ADDENDUM NO. KB - 03

**NEWINGTON TRANSITION ACADEMY &
OFFICES RELOCATION**
NEWINGTON TOWN HALL
NEWINGTON, CT
KBA #11004.00

Date: March 28, 2011
Page: 1 of 4

SKAR-3.01

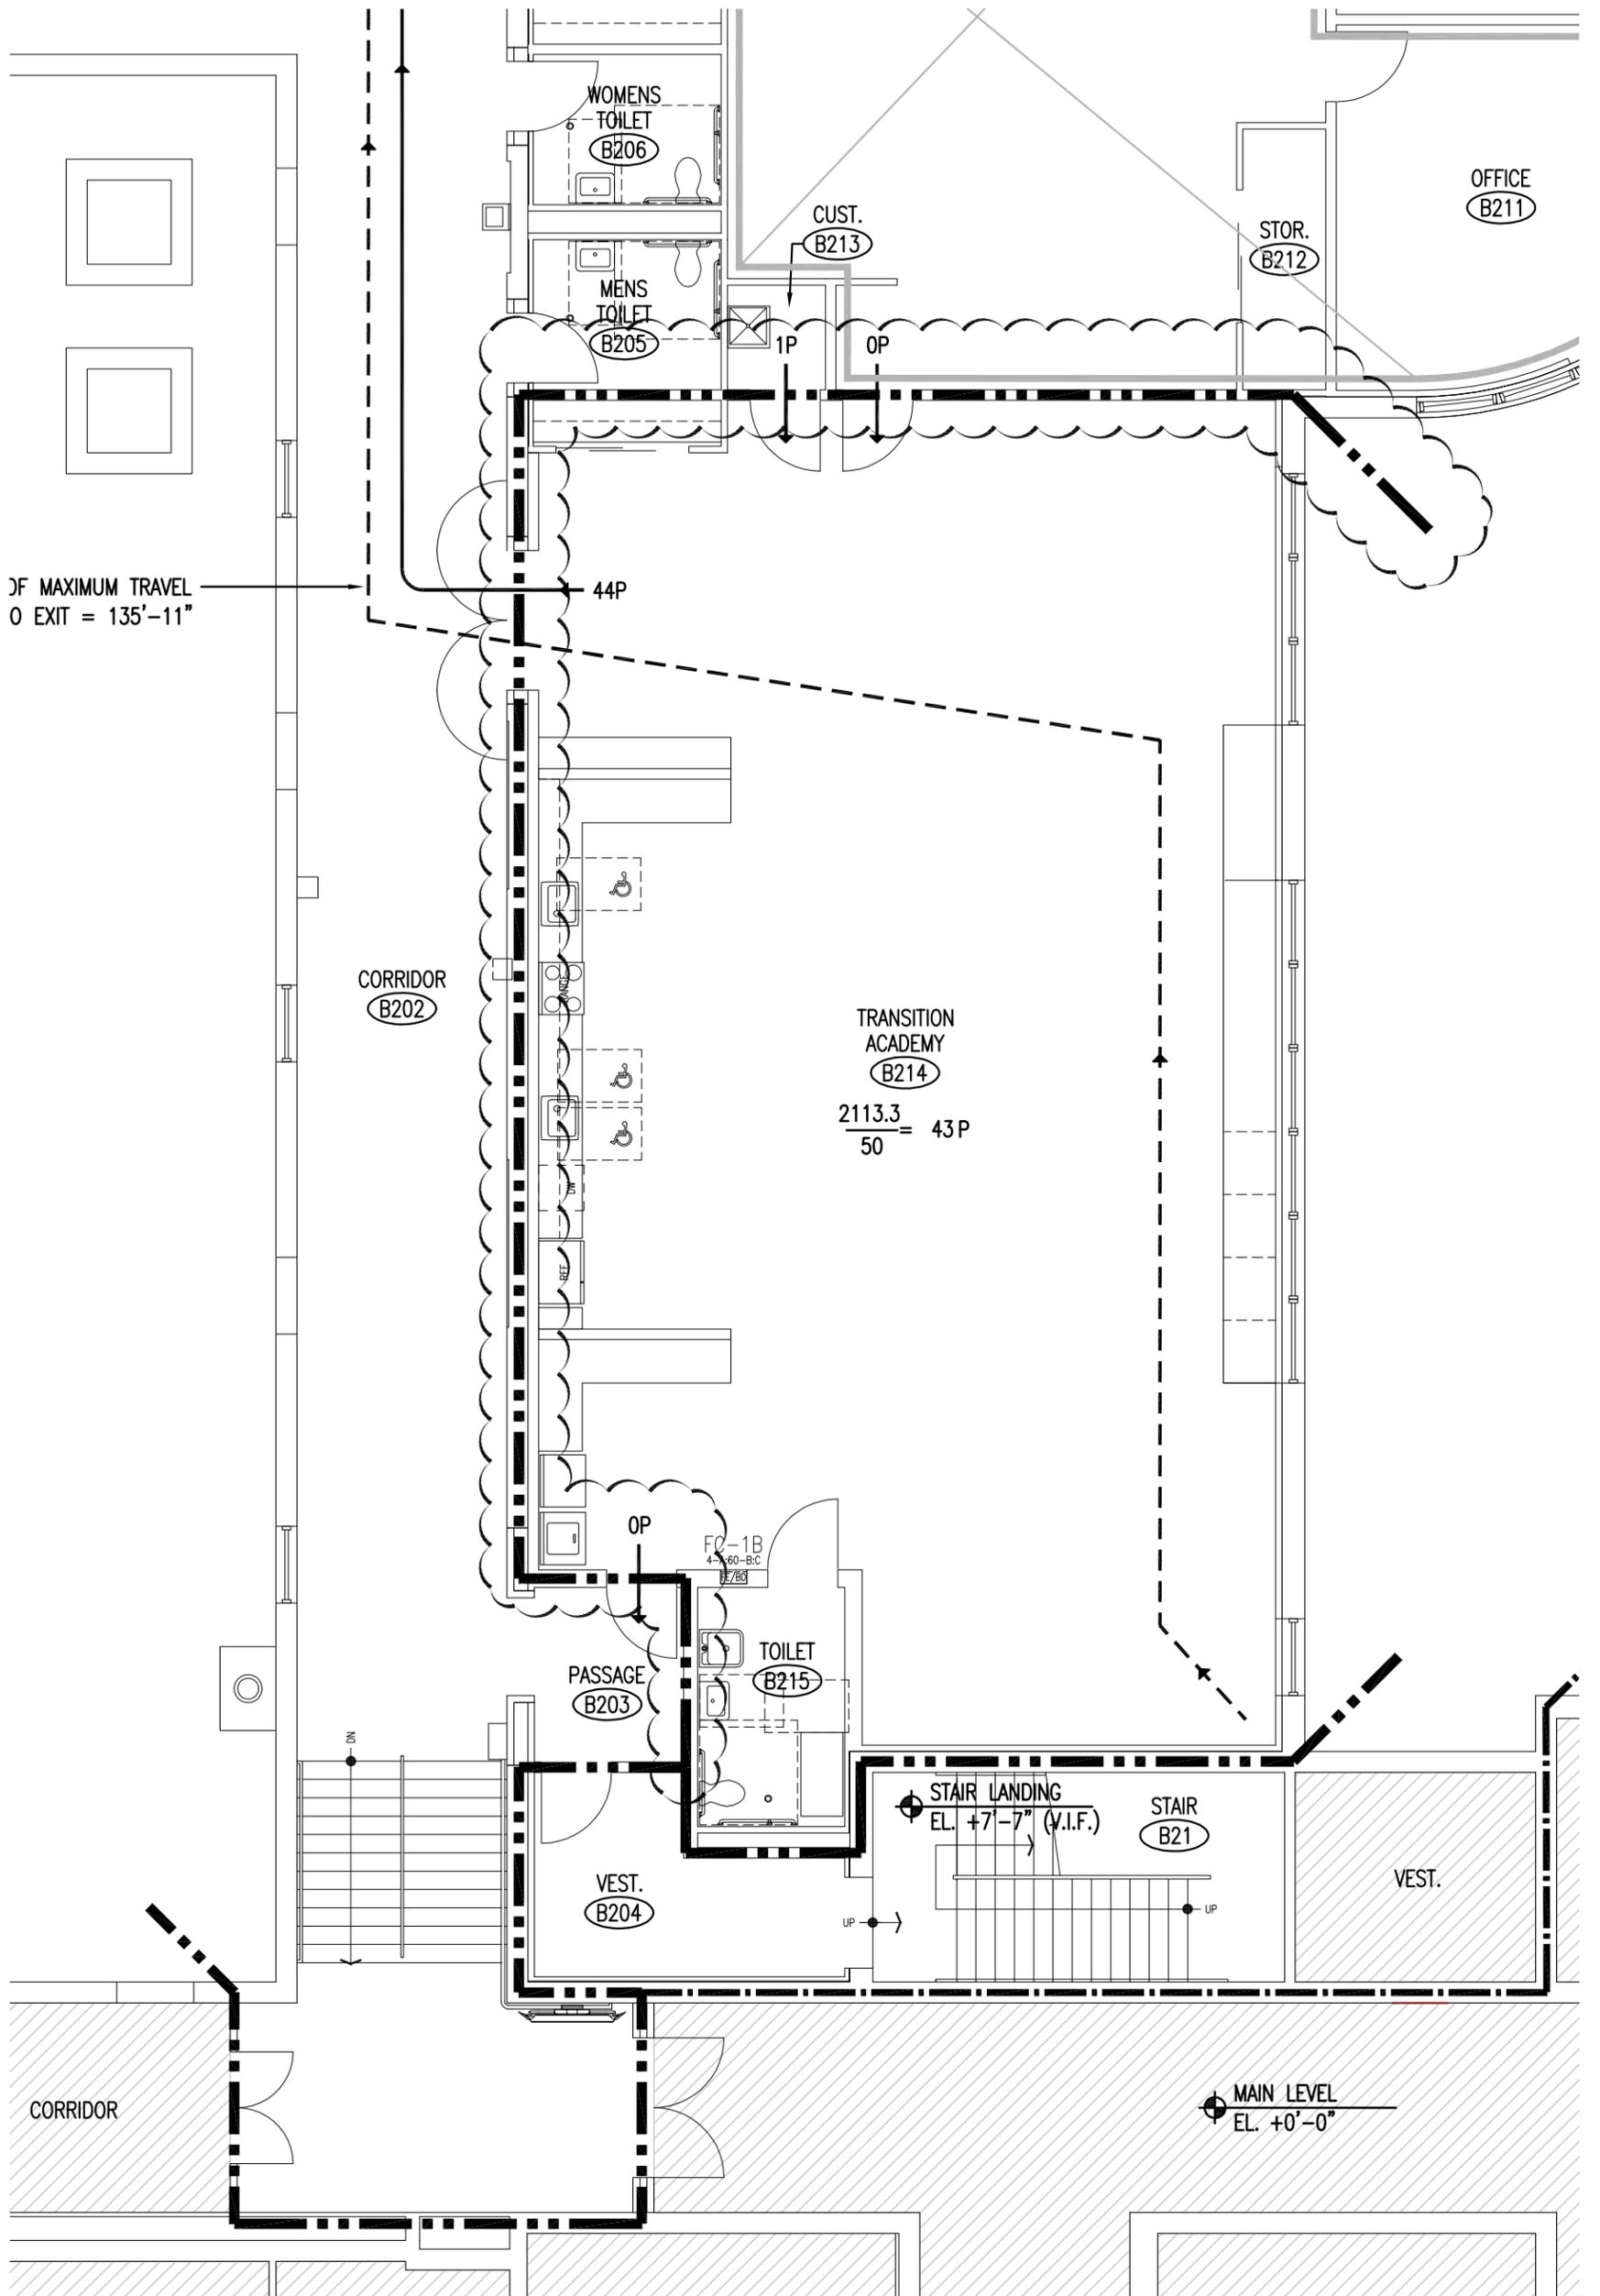
AR-1 AESBESTOS ABATEMENT & LEAD PAINT DEMOLITION PLAN

1/AR-1: Revise as per attached SKAR-3.01.

SKA-3.01

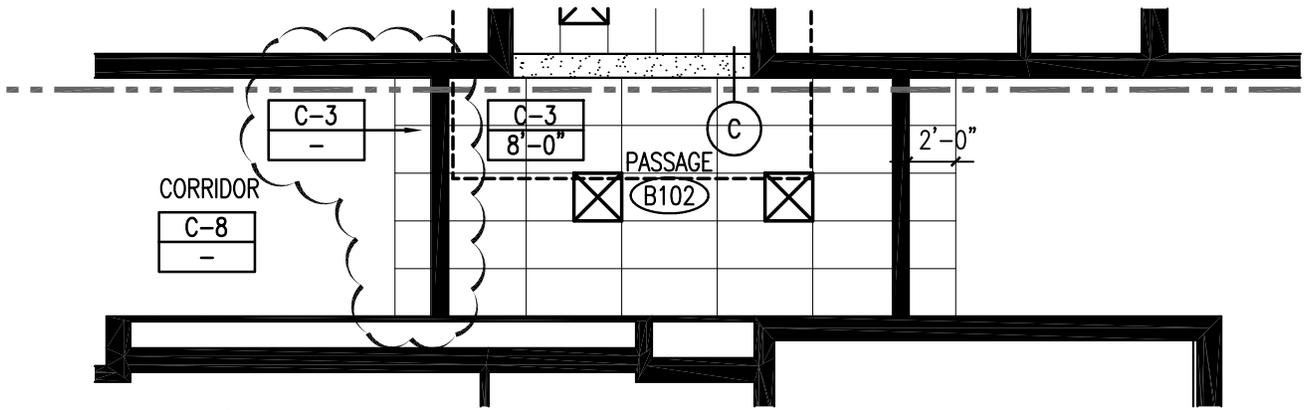
R1.02 CODE PLANS

Drawing 3/R1.02: Delineations of fire ratings are to be revised as per attached SKA-3.01.

3 1/A2.02 - REFLECTED CEILING PLAN - EAST WING - MAIN LEVEL
SCALE: 1/8" = 1'-0"

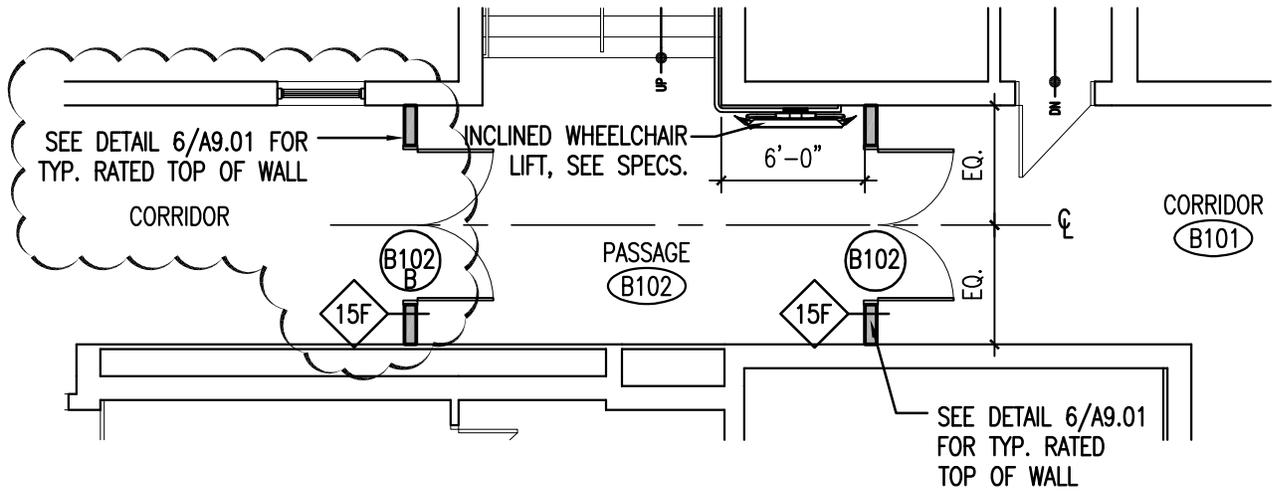
Drawing 1/A2.02: Provide new ceiling in existing corridor (north of north wall of Passage B102) to terminate at south jamb of existing window opening. See attached 3/SKA-3.02.

2 1/A1.02 - FLOOR PLAN - EAST WING - MAIN LEVEL
SCALE: 1/8" = 1'-0"

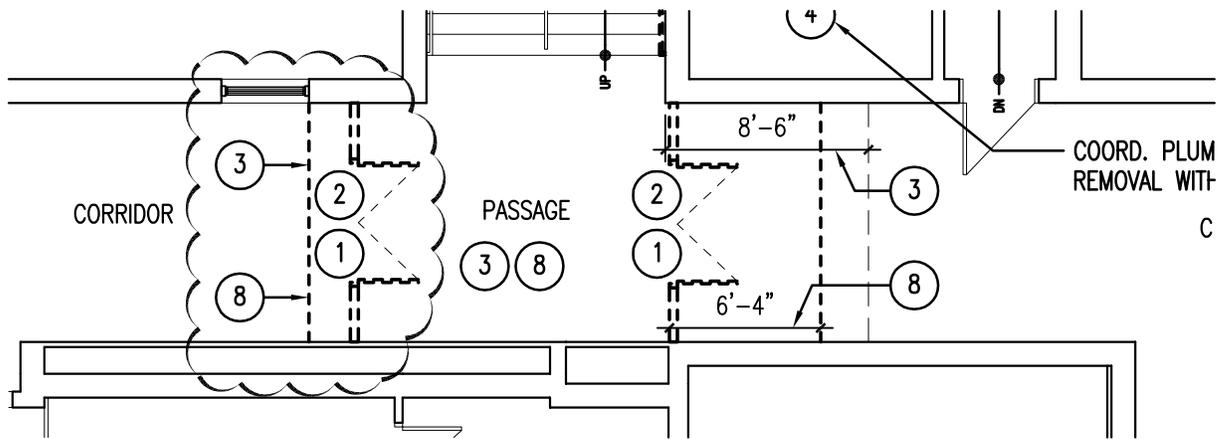
Drawing 1/A1.02: Add new wall and door as per attached 2/SKA-3.02.

Drawings 2/A1.02: Demo as per attached 1/SKA-3.02.

DATE: 3/28/2011 DRAWN: SPM DRAWING NO.:
SCALE: 1/8" = 1'-0" PROJECT NO.: 11004.00 **SKA-3.03**

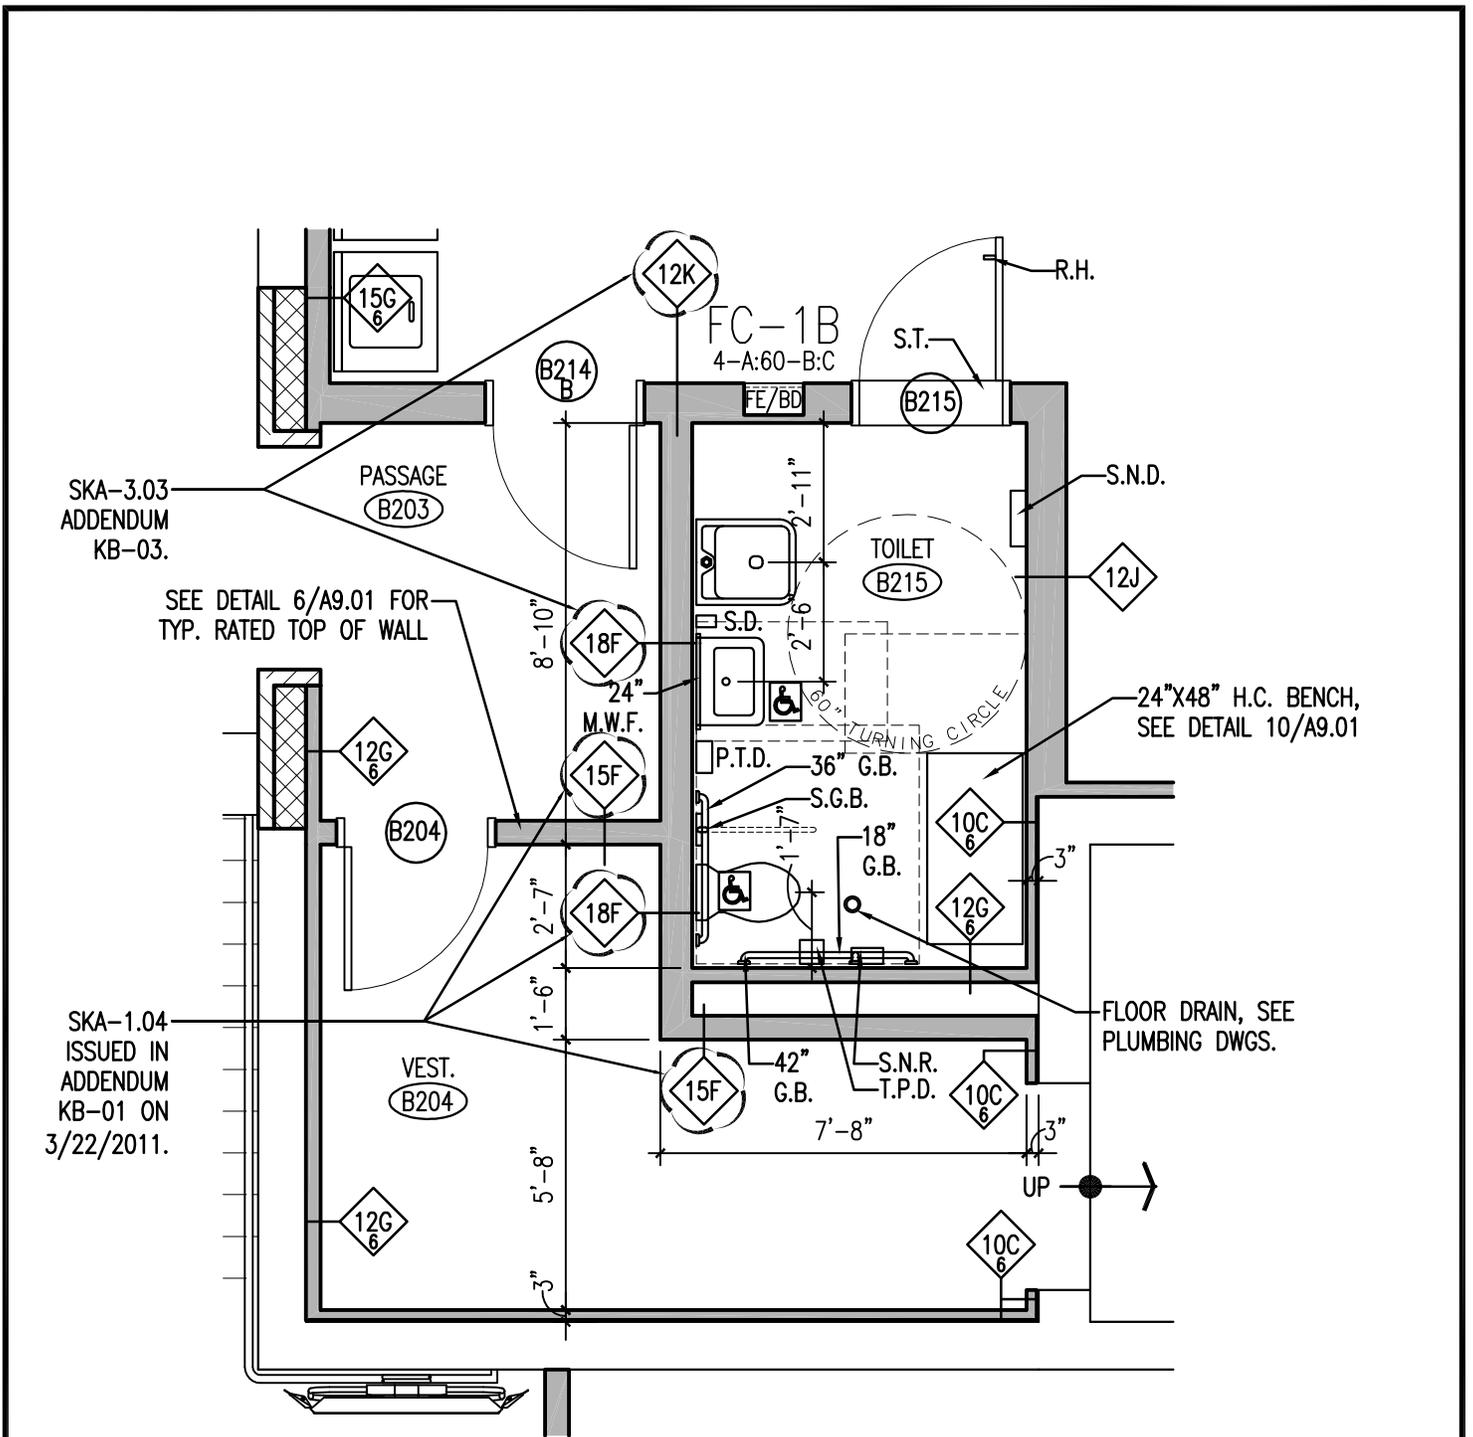
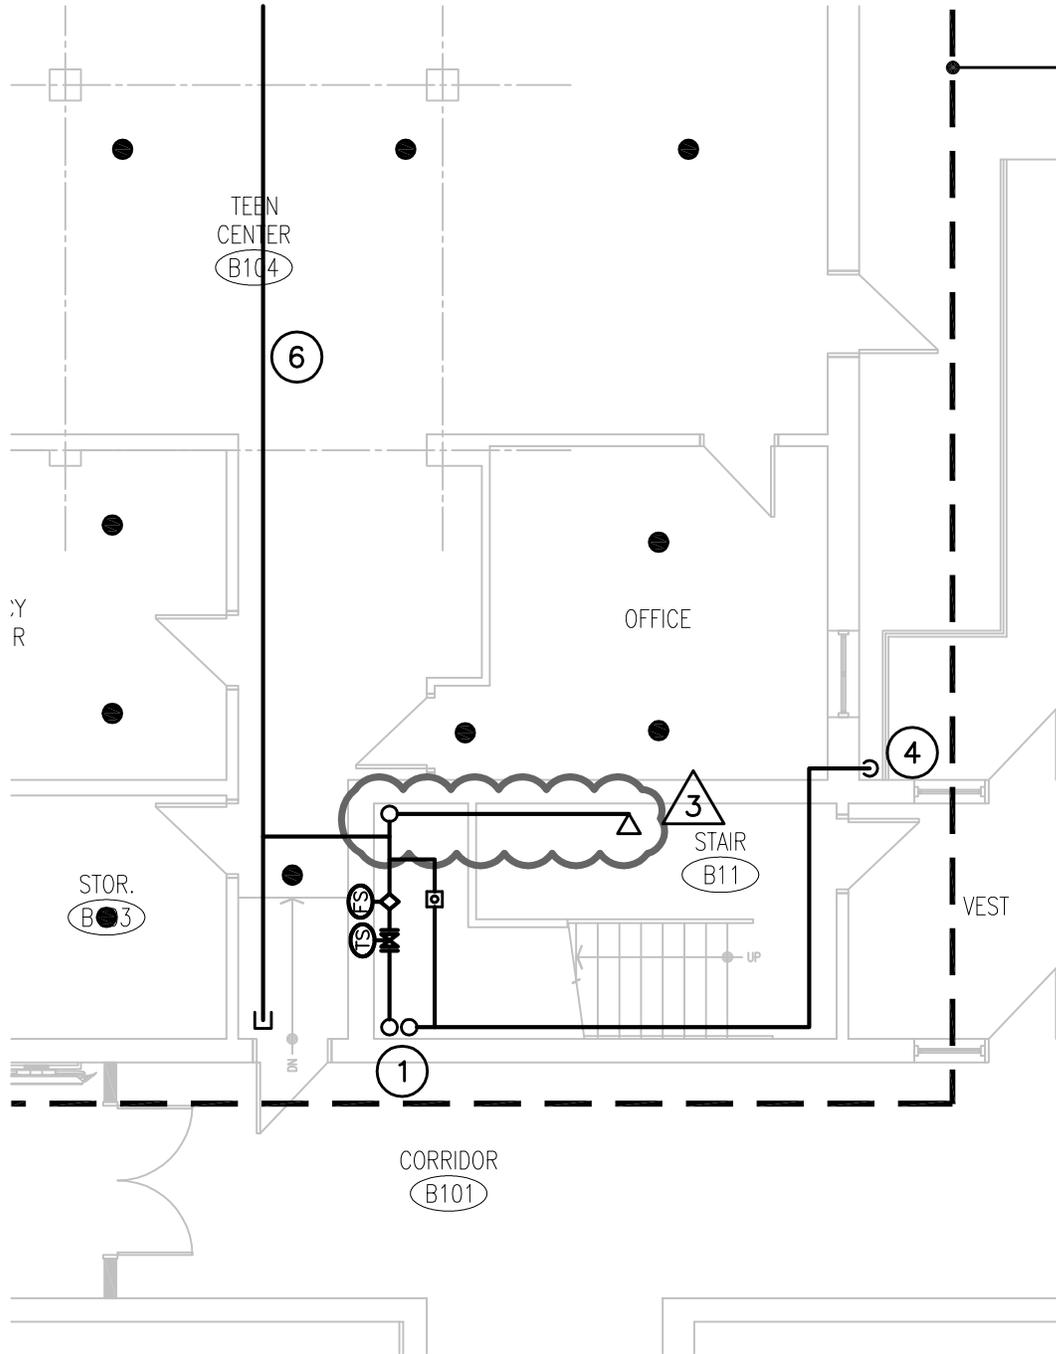
Detail 3/A4.01: Wall types at Passage B203 are revised as per attached SKA-3.03.

DRAWING NO.:
SKFP-3.01

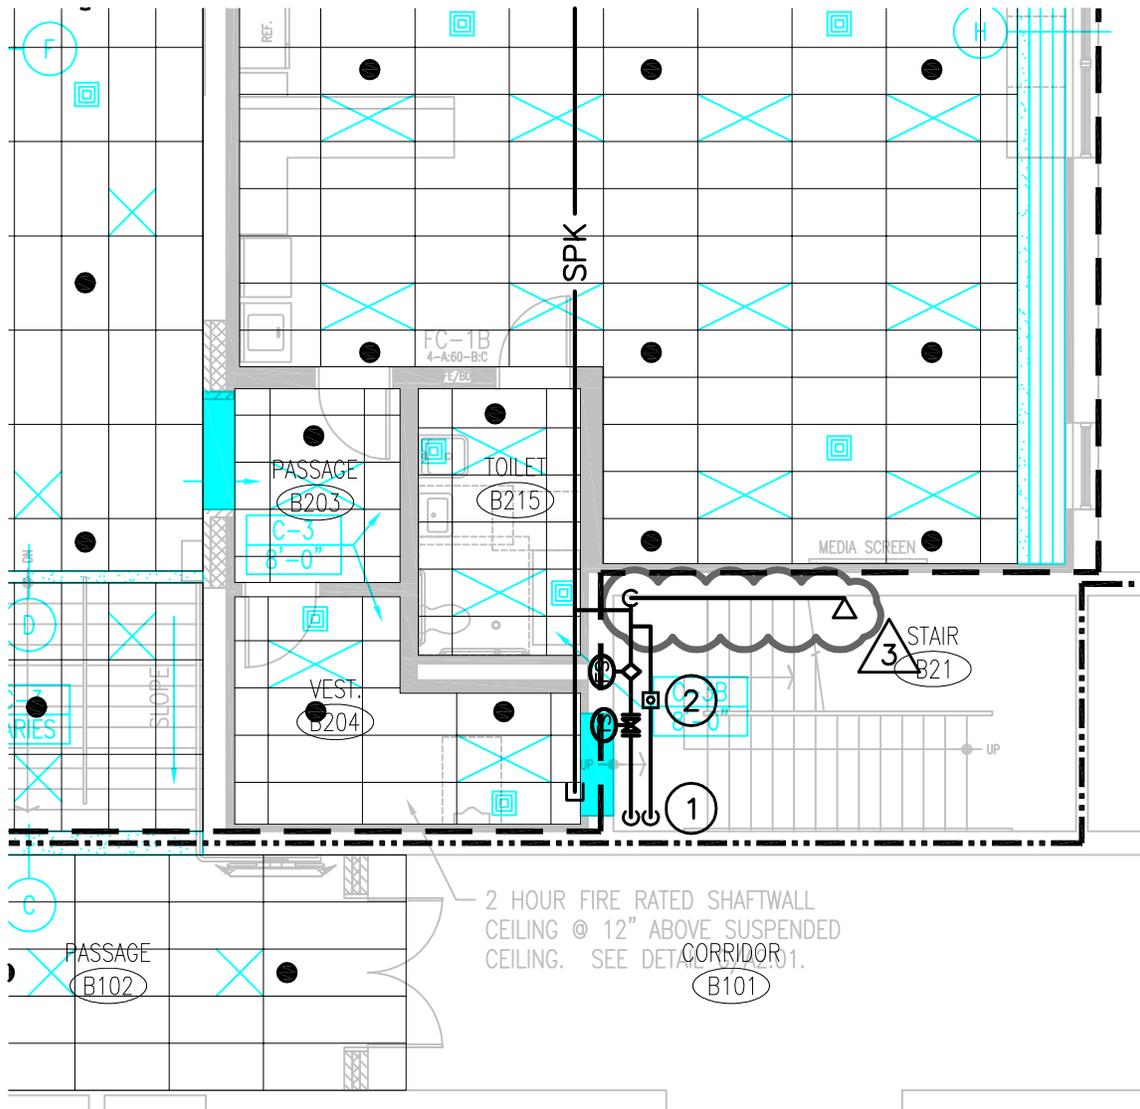
TITLE: EAST WING - MAIN LEVEL
FIRE PROTECTION REVISIONS
